PROJECT : NA1
Quanta Computer Inc.

NA1/QA1 Schematic EC Tracking Record B (for A --> B) Nov. 22, 2006

Size	Document Number	Rev
	EC list	2A
Date:	Friday, March 23, 2007	Sheet 53 of 55

PROJECT : NA1 Quanta Computer Inc.		Rev
Size	Document Number	2A
	CH7307	
Date:	Friday, March 23, 2007	Sheet 41 of 55

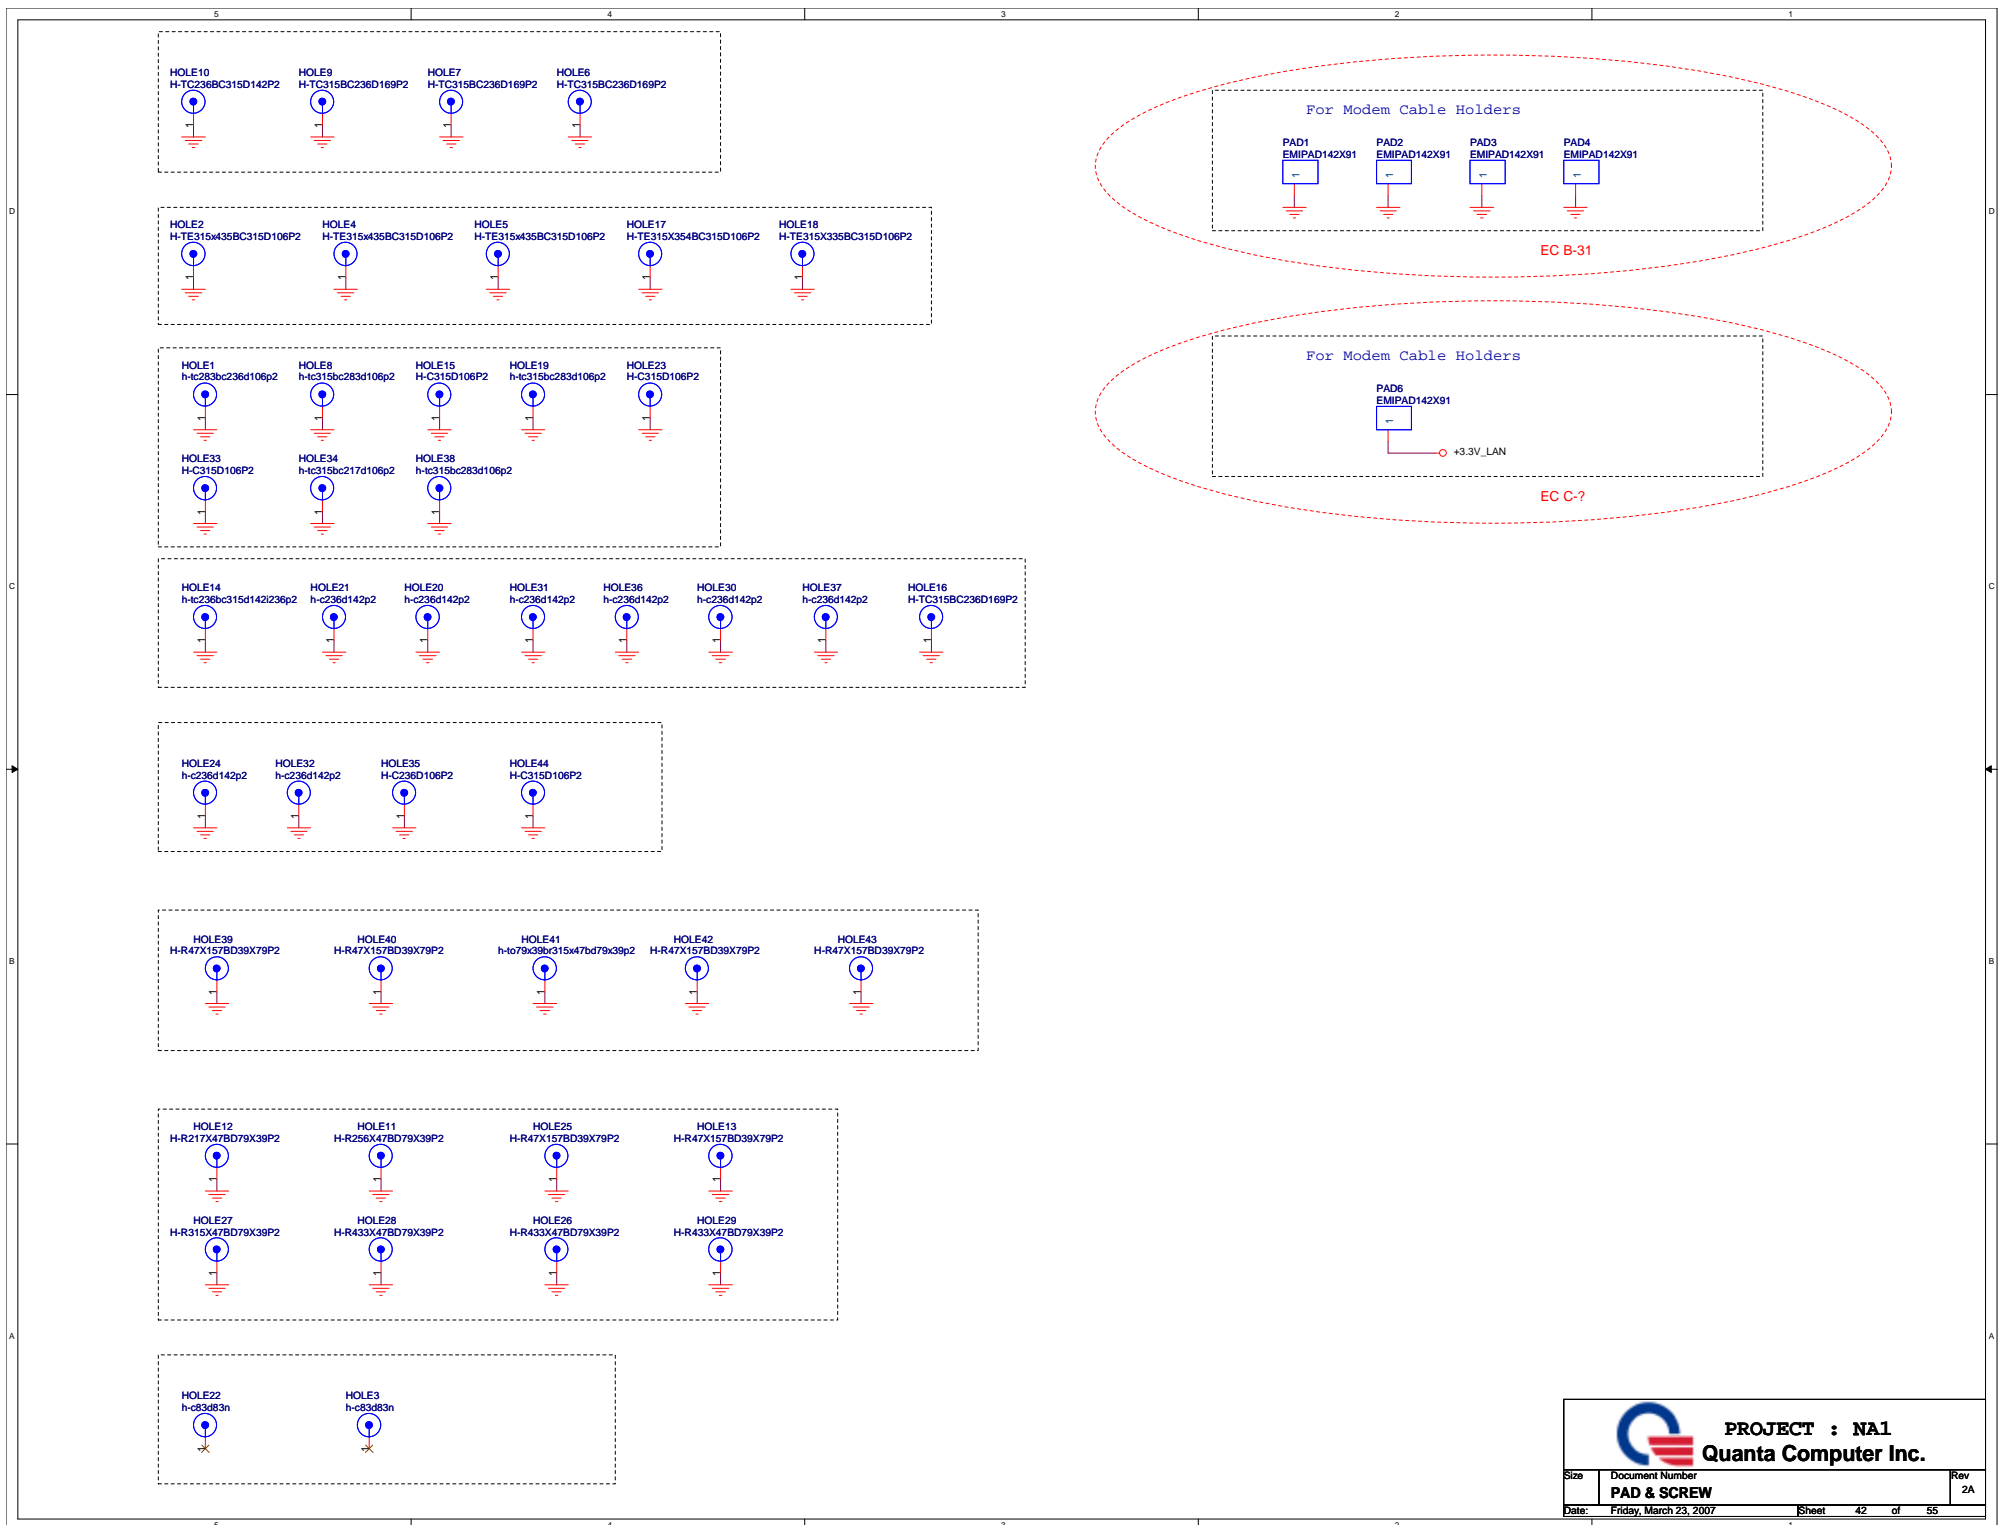
EC B-28
